Alternative Radiological Source Terms for Evaluating Design Basis Accidents at Nuclear Power Plants

001 BWROG22-1-403r0 BWROG Comments on DG-1389 2022-06

BWROG22-1-403r0
June 17, 2022

SUBJECT: Comments on Draft Regulatory Guide DG-1389

Table 1 BWR Core Inventory Fraction Released into Containment Atmosphere

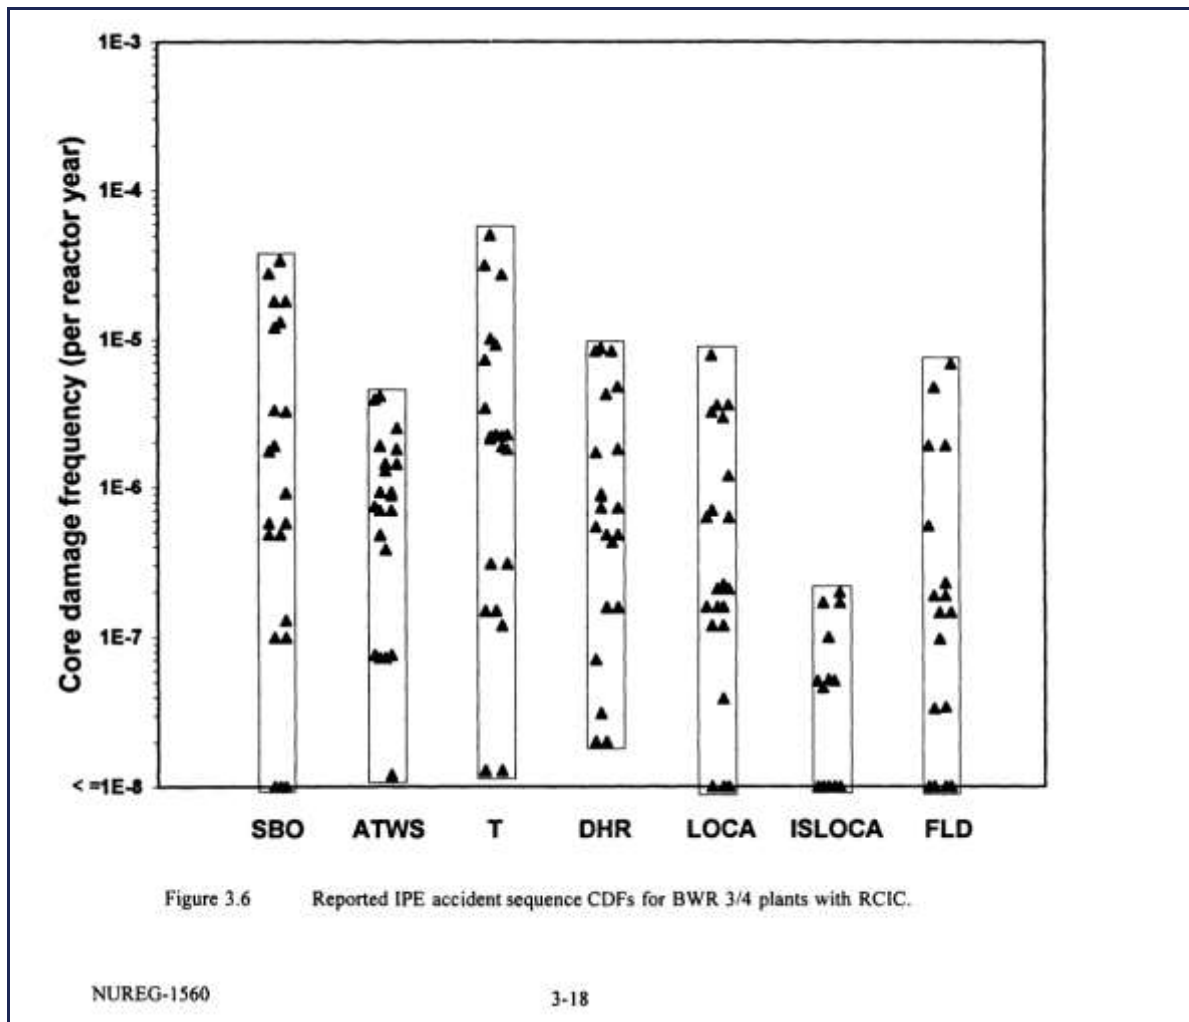
A comparison of the changes in maximum hypothetical accident (MHA) release fractions between BWRs (Table 1) and PWRs (Table 2) identified a significant increase in the BWR halogen release fractions with no indication in either SAND2011-0128 or DG-1389 as to the cause. This increase will adversely affect the ability of BWRs to comply with Reg Guide 1.183 Rev. 1. A comparison to the PWR analyses suggests that the accident sequences may be responsible for this impact.

The original alternative source term in NUREG-1465 was based on a range of accident sequences. As described in Section 3.1 of NUREG-1465, these sequences were based on the accident sequence data in NUREG-1150, which assessed the core damage risks for five representative plants using the PRA methods and severe accident modeling tools available in the late 1980s. The dominant sequences were evaluated with the Staff's Source Term Code Package (STCP) and the MELCOR code and are listed in Table 3.1 of NUREG-1465. An updated version of the core damage risk to the entire fleet is NUREG-1560, which was based on industry-prepared Individual Plant Evaluations (IPEs). As shown in Figure 3.6 of NUREG-1560 (reproduced below) for the majority of operating BWR plants (BWR/3 and BWR/4), there continues to be a broad diversity in the accident scenarios leading to core damage.

SAND2011-0128 updates NUREG-1465 with higher core exposures utilizing the latest NRC's MELCOR methodology. The accident sequences that were analyzed to develop the PWR release fractions are listed in Table 5 of the Sandia report and include a variety of accident types. However, for the BWR release fractions, Table 3 of the Sandia report indicates that nearly all of the evaluations were based on station blackout (SBO) sequences. As illustrated in Figure 3.6 of NUREG-1560, the core damage risk from SBO is similar to that from other accident sequences. Considering the recent modifications to address Fukushima SBO risk, the core damage risk from SBO is considerably lower than the NUREG-1560 data taken from the late 1990s.

Section A-2.1 of DG-1389 characterizes these release fractions as airborne releases into the BWR drywell. It is also unclear from the Sandia report whether suppression pool scrubbing was credited in determining the release fractions from a BWR SBO. Credit for pool scrubbing can significantly decrease the airborne activity since the SBO-related releases would be released via spargers underwater in the suppression pool.

Consistent with the PWR analysis in SAND2011-0128, the BWR release fractions should be re-evaluated based on accident sequences that are a more representative of BWR core damage risks. Any sequences that involve releases through the pool spargers should take credit for suppression pool scrubbing.
